CMB Meeting Minutes #180

SUBJECT: Configuration Management Board Meeting # 180 – Rev. No. 0

Contract No. 1300 Stations, Surface, Track and Systems Date 8-6-2014
 PCC No. 0014 STS
 PCC Title Traffic Signal and Streetlight Changes
 PCC Initiator Mike Acosta Dept. CM

THIRD STREET LIGHT RAIL PROGRAM
 PHASE 2 - CENTRAL SUBWAY
 SURFACE, TRACK AND SYSTEMS
 TRAFFIC SIGNALS
 FOURTH STREET AND HARRISON STREET
 TRAFFIC SIGNAL PLAN

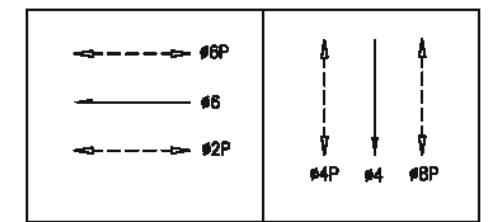
1. Scope of work at 4th and Harrison intersection:
 - a. Delete new trolley pole 405 from scope of work.
 - b. Replace existing 8' mast arm with new 20' mast arm which includes transferring existing signal from old mast arm to new mast arm.

- c. Add 20LF of traffic signal conduit and 2200LF traffic signal wiring.
 - d. Remove existing Pole Z.
 - e. Relocate 1 pedestrian signal.
 - f. Remove streetlight pole and provide new streetlight and wiring on traffic signal pole (in contract).

- g. Refer to RFI Nos. 69, 70, 71, 72, 73, 76, 77, 78, 79 and Sketches "SK_STS_ET101", "SK_STS_ET102", "SK_STS_OV112".
2. Scope of work at 4th and Bryant intersection:

THIRD STREET LIGHT RAIL PROGRAM
 PHASE 2 - CENTRAL SUBWAY
 SURFACE, TRACK AND SYSTEMS
 TRAFFIC SIGNALS
 BRYANT STREET AND FOURTH STREET
 DEMOLITION PLAN

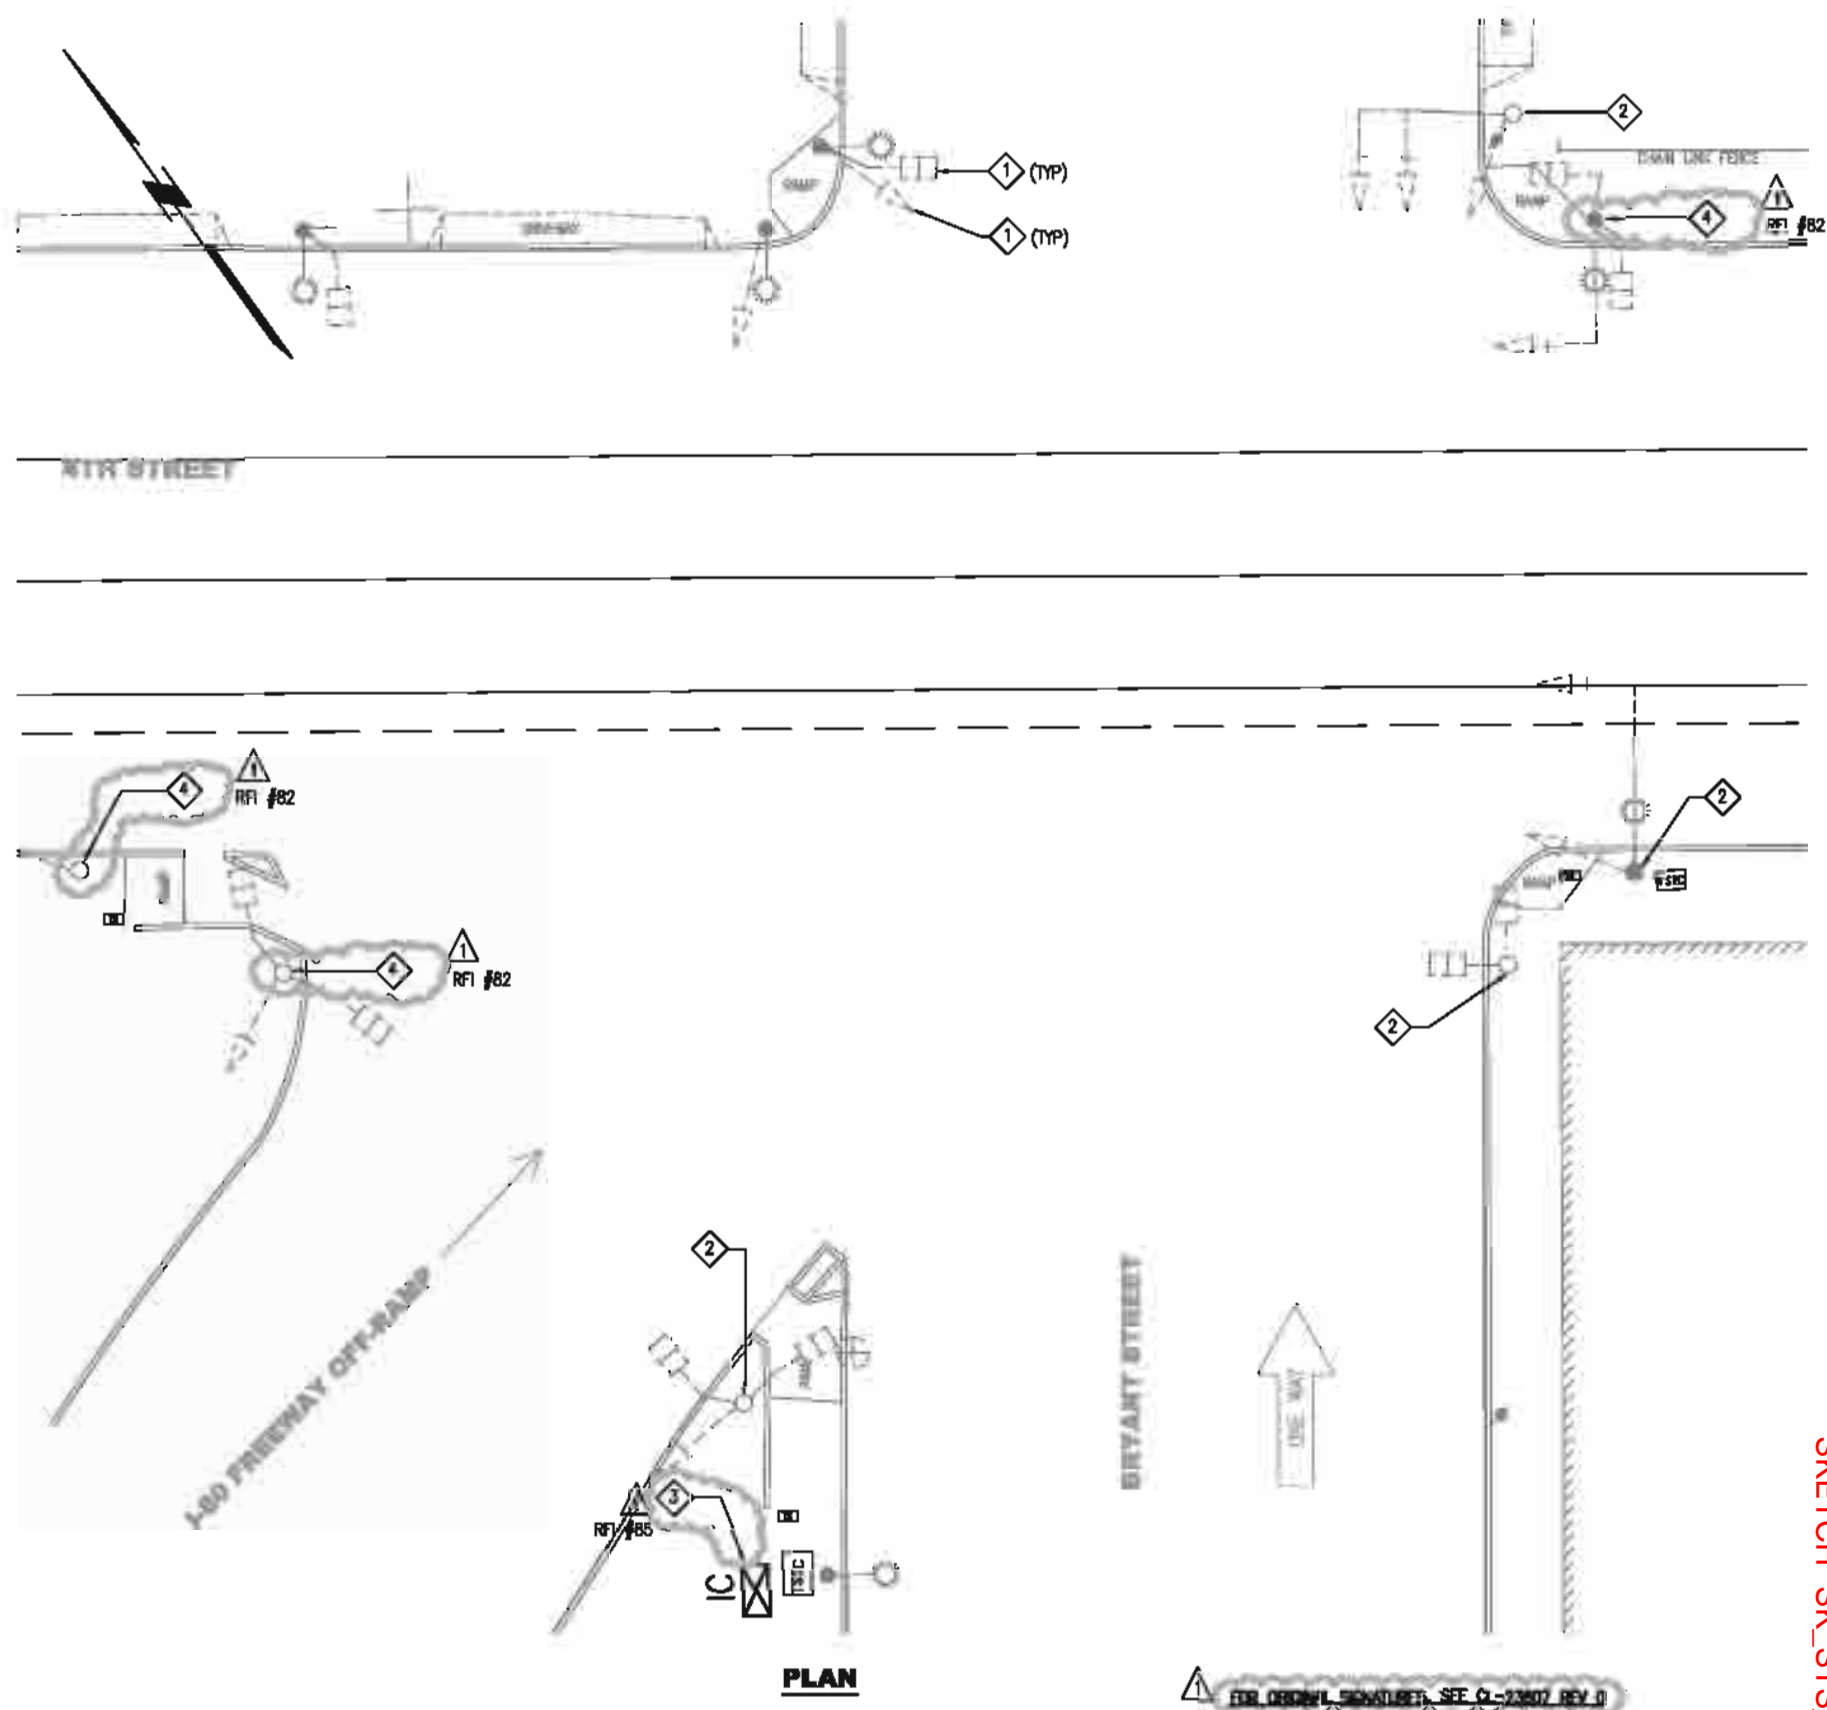
- a. Remove and dispose 4 existing poles and foundations
 - b. Remove existing traffic signal controller and replace with new controller
 - c. Revise 6 traffic signal mounting types

- d. Refer to RFI Nos. 81, 82, 83, 85, 132, 140, 141, 319, 320, 324, 343 and Sketches "SK_STS_ET103", "SK_STS_ET104".
3. Scope of work at 4th and Brannan intersection:

THIRD STREET LIGHT RAIL PROGRAM
 PHASE 2 - CENTRAL SUBWAY
 SURFACE, TRACK AND SYSTEMS
**TRAFFIC SIGNALS
 BRYANT STREET AND FOURTH STREET
 TRAFFIC SIGNAL PLAN**

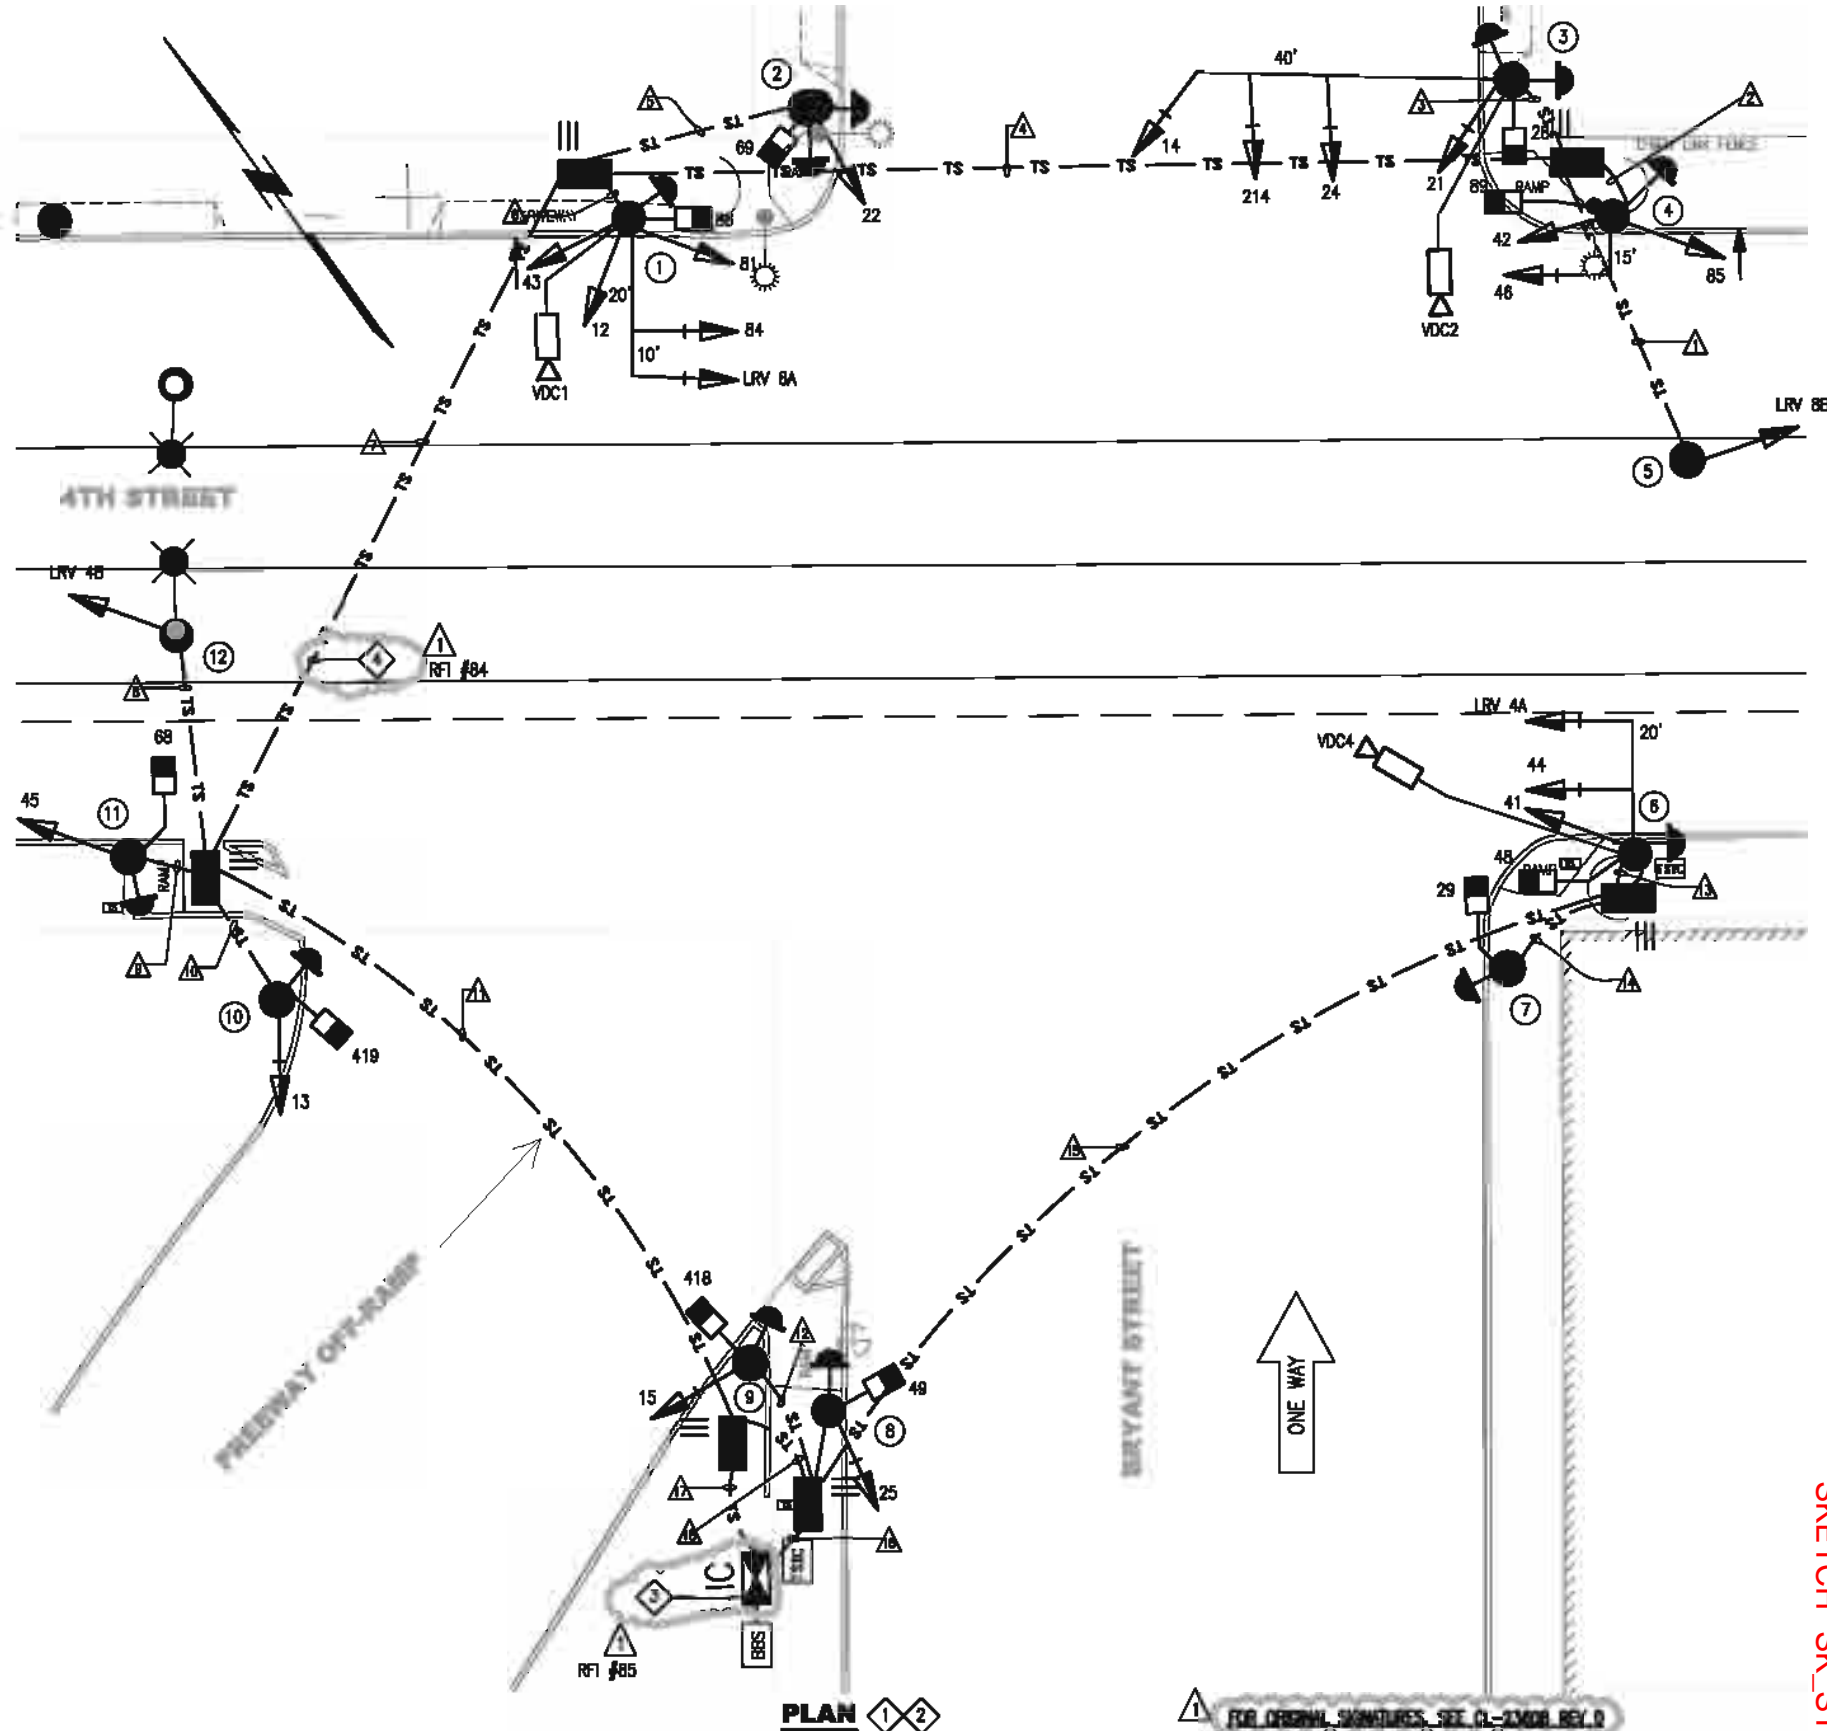
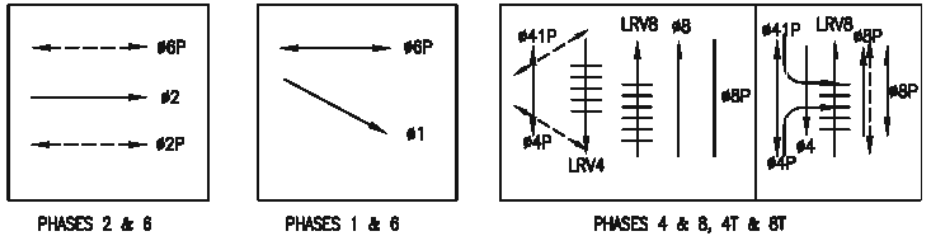
1. SEE DRAWING ET-104 FOR POLE, EQUIPMENT, CONDUIT, AND WIRING SCHEDULES.
2. CONTRACTOR SHALL FURNISH AND INSTALL EMERGENCY VEHICLE DETECTOR SYSTEM (OPTION GPS DETECTOR UNIT) AS PART OF TRAFFIC SIGNAL MODIFICATION WORK. PROGRAMMING AND TESTING OF DETECTOR SYSTEM WILL BE COORDINATED WITH SFMTA.
3. PROVIDE (N) TRAFFIC SIGNAL CONTROLLER AND (N) FOUNDATION IN SAME LOCATION AS (E) CONTROLLER.
RFI #85
4. CONNECT TO (E) 2" (PROVIDED UNDER CONTRACT 1252).
RFI #84

THIRD STREET LIGHT RAIL PROGRAM
 PHASE 2 - CENTRAL SUBWAY
 SURFACE, TRACK AND SYSTEMS
**TRAFFIC SIGNALS
 BRANNAN STREET AND FOURTH STREET
 DEMOLITION PLAN**

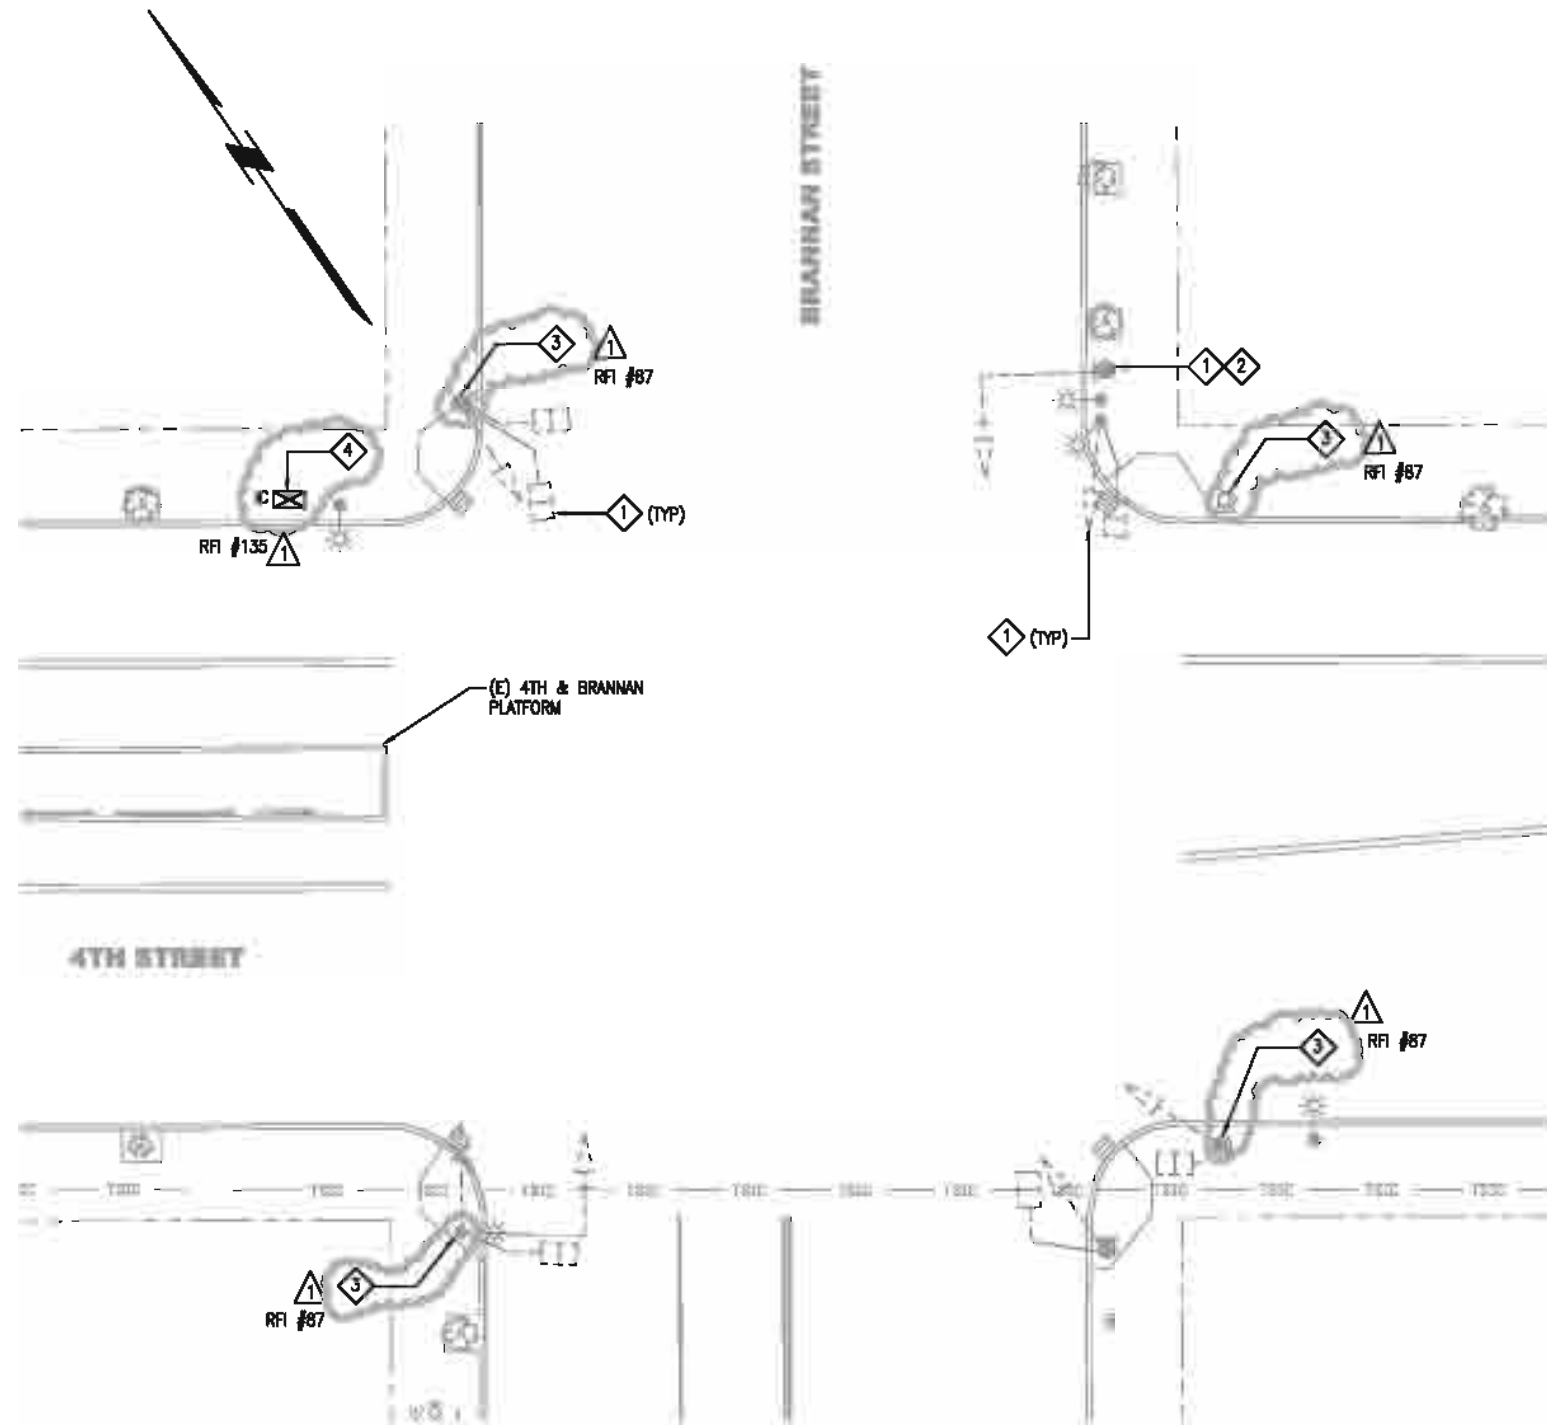
- a. Remove 4 existing poles and foundations
 - b. Add 1 traffic signal head
 - c. Demolish traffic signal controller foundation
 - d. Revise 3 traffic signal mounting types

- e. Refer to RFI Nos. 87, 88, 135, 326, 327, 342 and Sketches "SK_STS_ET106", "SK_STS_ET108".
4. Scope of work at 4th and Townsend intersection:
 - a. Remove 1 existing poles and foundations

RFI #87

RFI #135

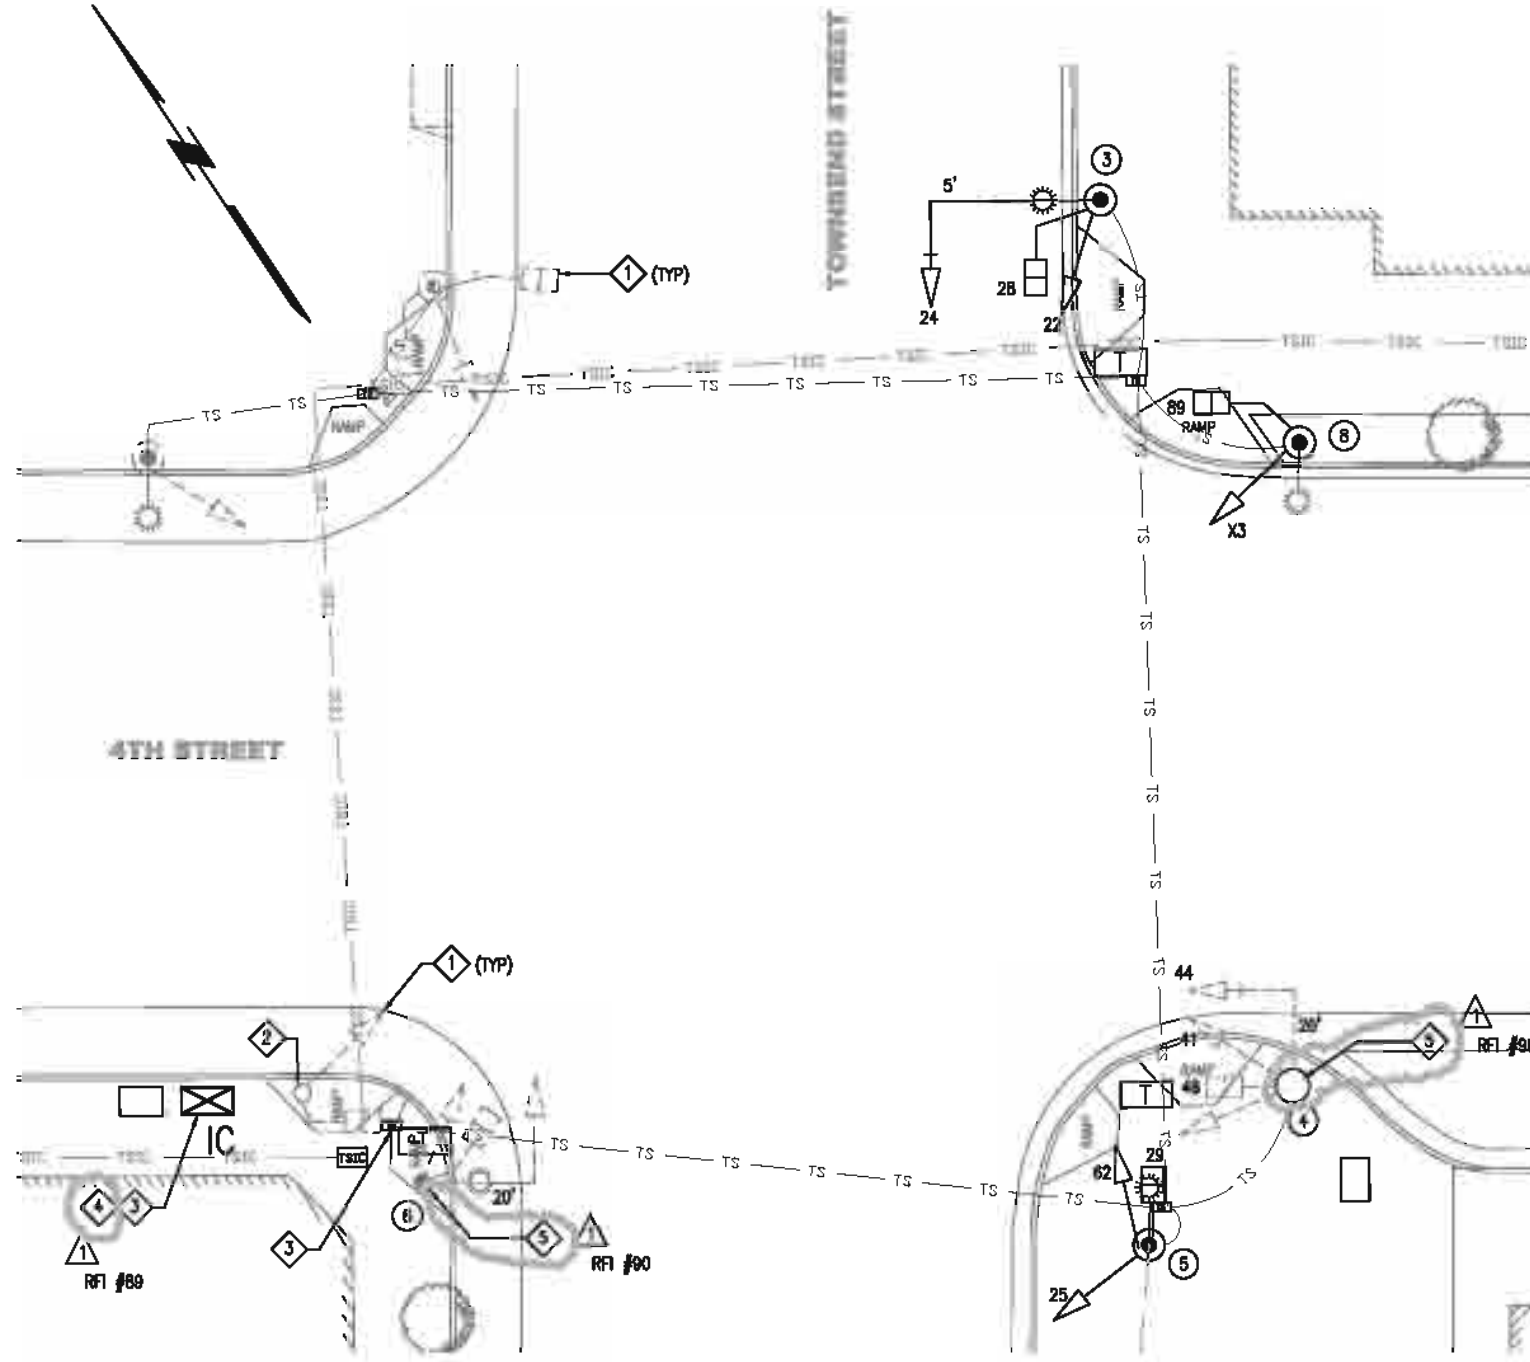
RFI #89
 ▲ 4. R/D (E) TRAFFIC SIGNAL CONTROLLER AND (E) FOUNDATION. REFER TO DRAWING ET-110 FOR (N) TRAFFIC SIGNAL CONTROLLER.

RFI #90
 ▲ 5. R/D (E) POLE AND (E) FOUNDATION.
